Project	IEEE 802.16 Broadband Wireless Access Working Group < http://ieee802.org/16 >
Title	Amendment to Idle Mode Service Primitives
Date Submitted	2007-03-09
Source(s)	JeeHyeon Na, Jaesun Cha, JungMo Moon and Sangho Lee jhna@etri.re.kr ETRI 161 Gajeong-dong, Yuseong-gu Daejeon 305-700 Korea
Re:	Contribution on comments to IEEE 802.16g/D8
Abstract	Re-definition of Idle mode service primitives in section 14.2.4.2
Purpose	Adoption
Notice	This document has been prepared to assist IEEE 802.16. It is offered as a basis for discussion and is not binding on the contributing individual(s) or organization(s). The material in this document is subject to change in form and content after further study. The contributor(s) reserve(s) the right to add, amend or withdraw material contained herein.
Release	The contributor grants a free, irrevocable license to the IEEE to incorporate text contained in this contribution, and any modifications thereof, in the creation of an IEEE Standards publication; to copyright in the IEEE's name any IEEE Standards publication even though it may include portions of this contribution; and at the IEEE's sole discretion to permit others to reproduce in whole or in pa

Figure 479—Subscriber mode transition diagram at NCMS (on BS or MS)

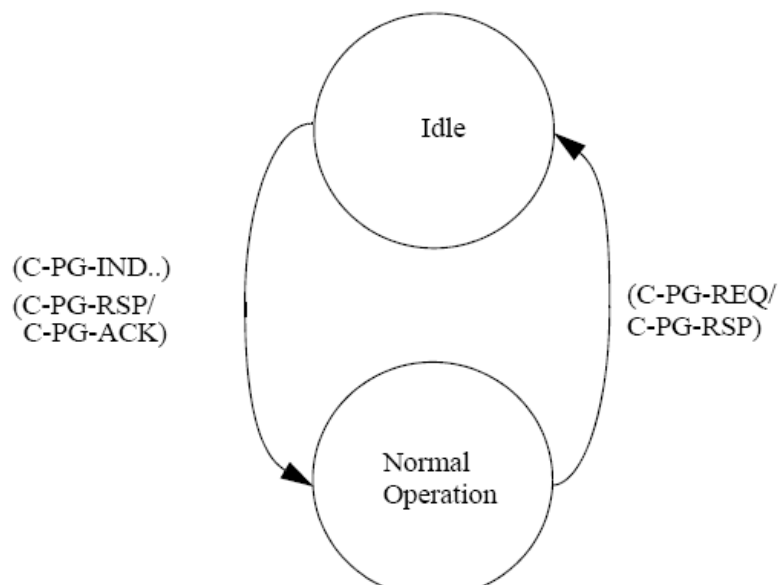
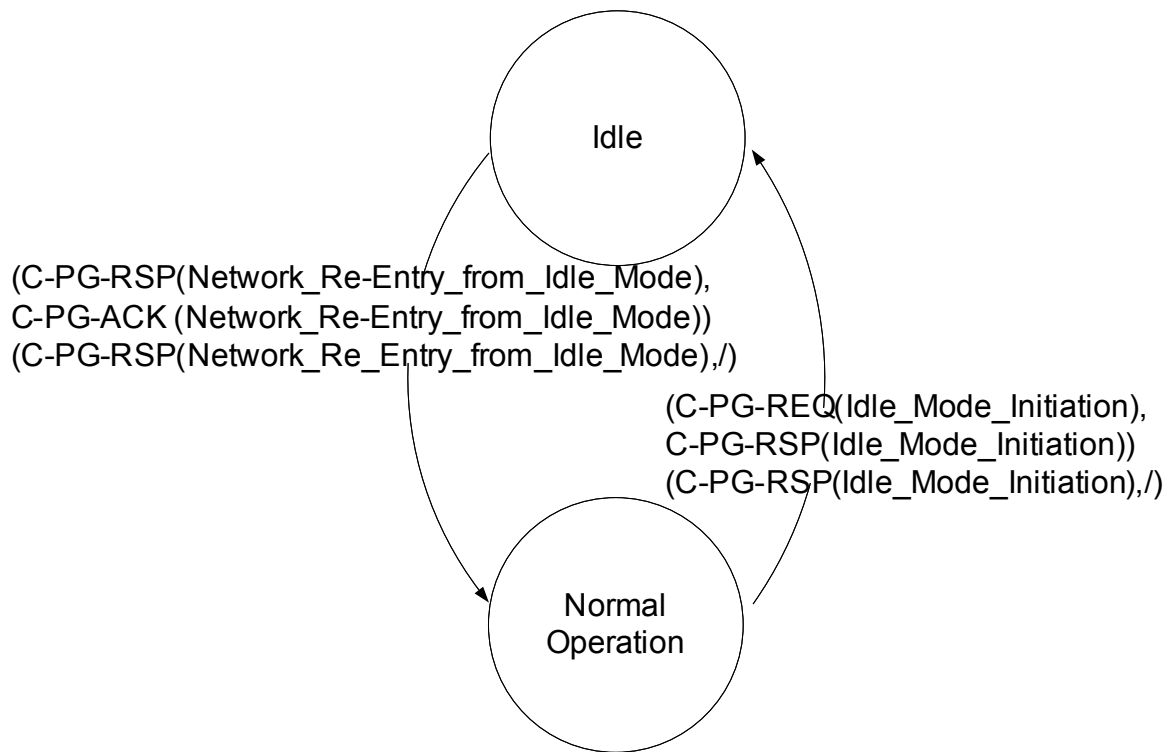
Subscriber mode management is described as informative in section 14.2.4 and it is managed at an MS, a BS and an NCMS. Figure 479 which shows subscriber mode transition diagram at NCMS is not clear whether for an NCMS on a BS and an MS side or not.

Therefore, we clarify figure 479 and the related texts in order to be used both NCMS at an MS and a BS side.

Figure 479 shows Subscriber Mode transition diagram at the NCMS with service primitives related with the Subscriber Mode transition. Subscriber Mode transition from Normal Operation to Idle Mode is performed by exchanging C-PG-REQ and C-PG-RSP between ~~a BS~~ an 802.16 entity and the NCMS after successful DREG-REQ message from the MS with De-Registration_Request_Code=0x01 or DREG-CMD message from the BS with Action Code = 0x05, where C-PG-REQ and C-PG-RSP are defined in 14.2.4.2.1 and 14.2.4.2.2, respectively. Subscriber Mode transition from Idle Mode to Normal Operation is initiated after exchanging ~~C-PG-IND~~, C-PG-RSP; and C-PG-ACK between an 802.16 entity ~~BS~~ and the NCMS, where ~~C-PG-IND~~, C-PG-RSP, and C-PG-ACK are defined in 14.2.4.2.4, 14.2.4.2.2, and 14.2.4.2.3, respectively.

Figure 480 – Idle mode initiation (NCMS on the BS side)

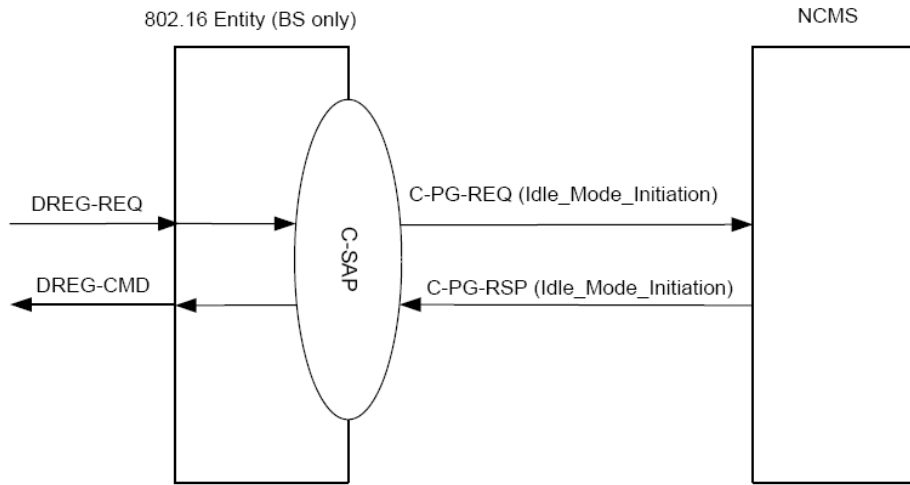
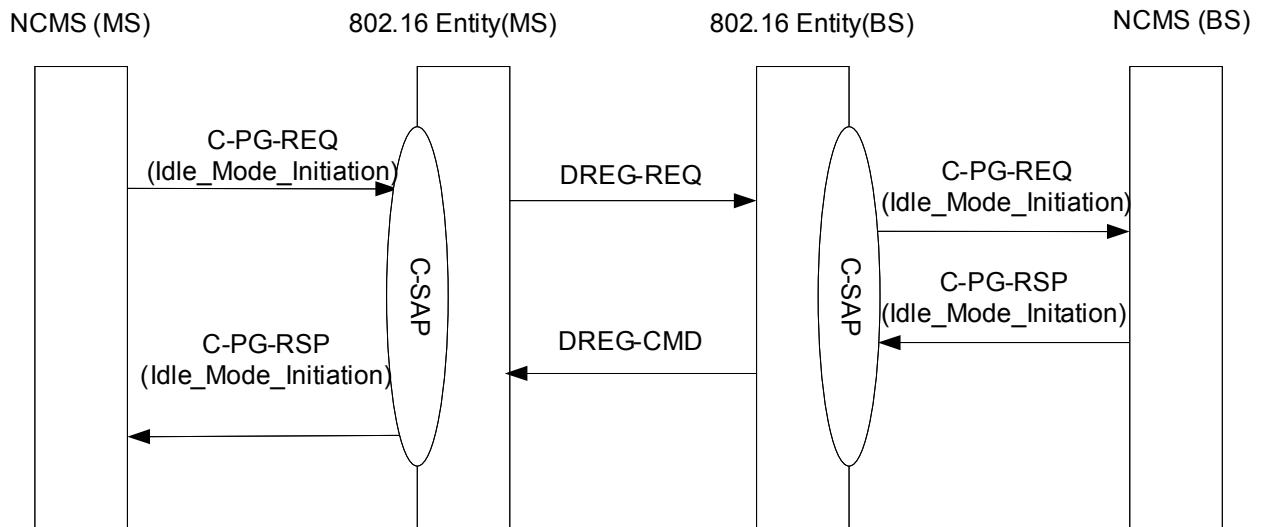
Therefore, we propose to change figure 480, 482, 483 to the figures which are included the service primitives between an 802.16 entity (MS) and an NCMS on the MS side and modify the related service primitives parameters in this contribution. And we also correct some editorial texts.

[Change the figure 480 and its title to as follows]

Figure 482- Paging Announcement

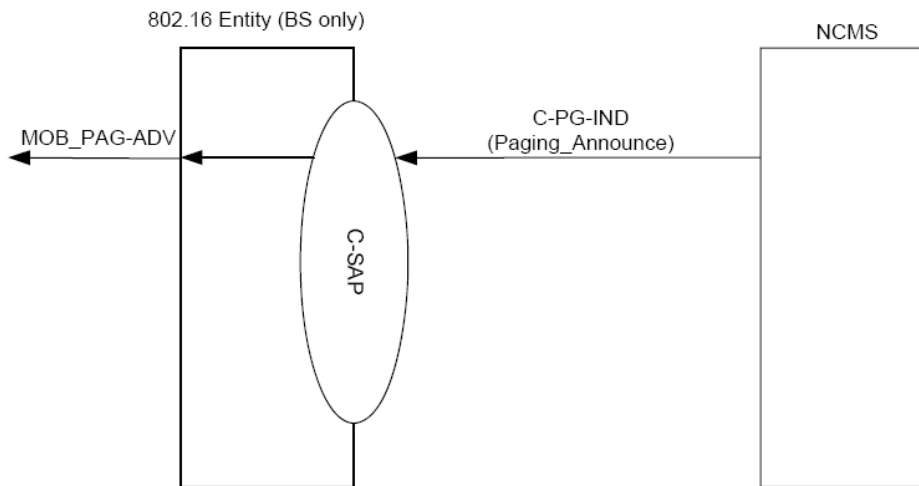
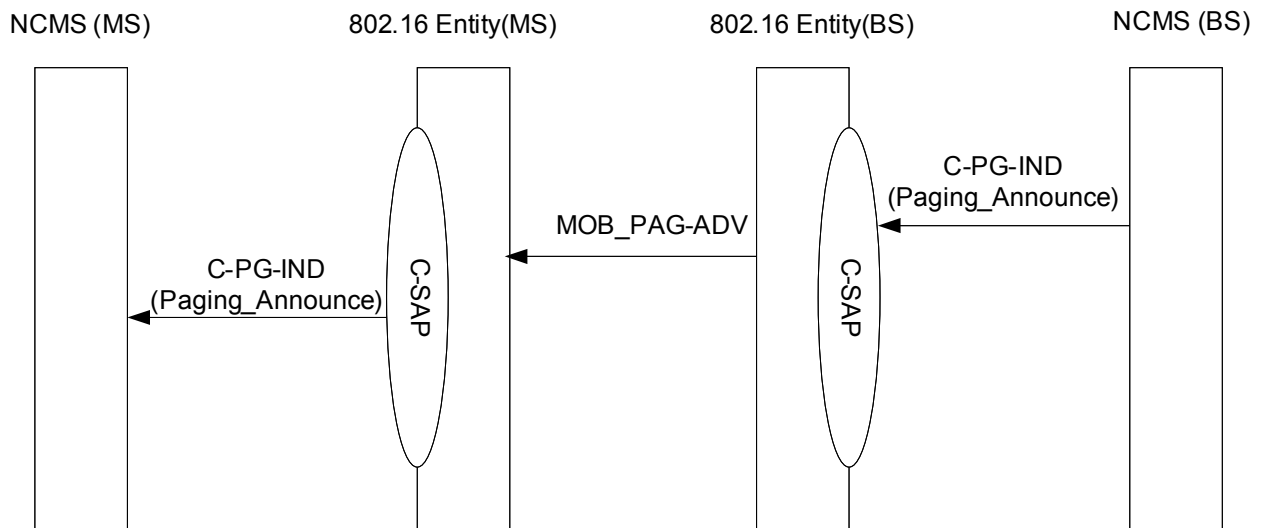
[Change the figure 482 to the following figure Section 14.2.4.2]

Figure 483- Network re-entry from Idle mode primitives

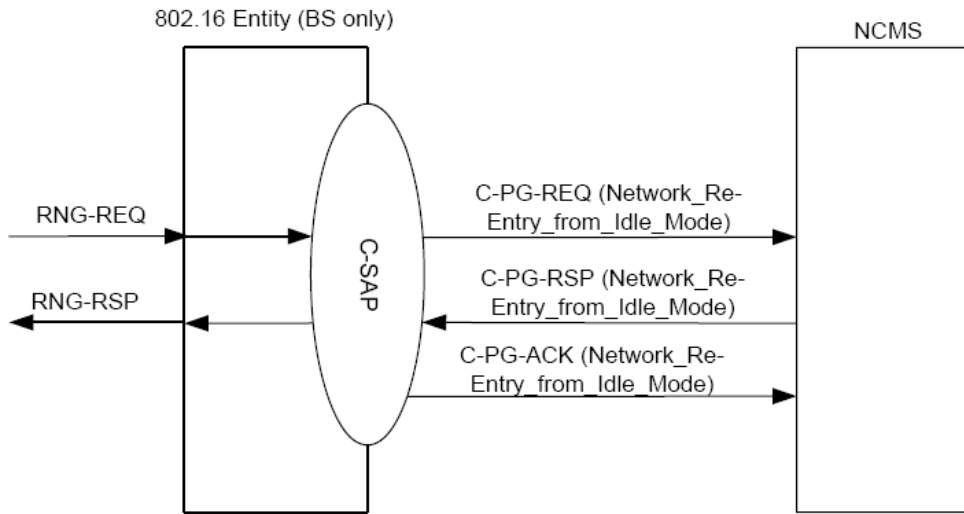
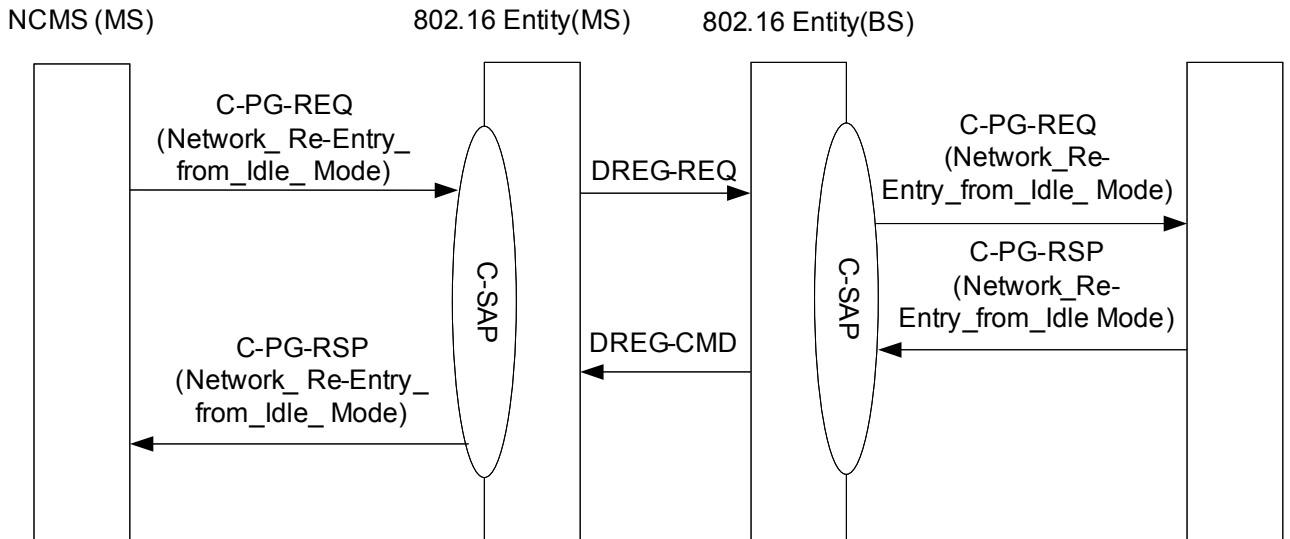
[Change the figure 483 to the following figure in 14.2.4.2]
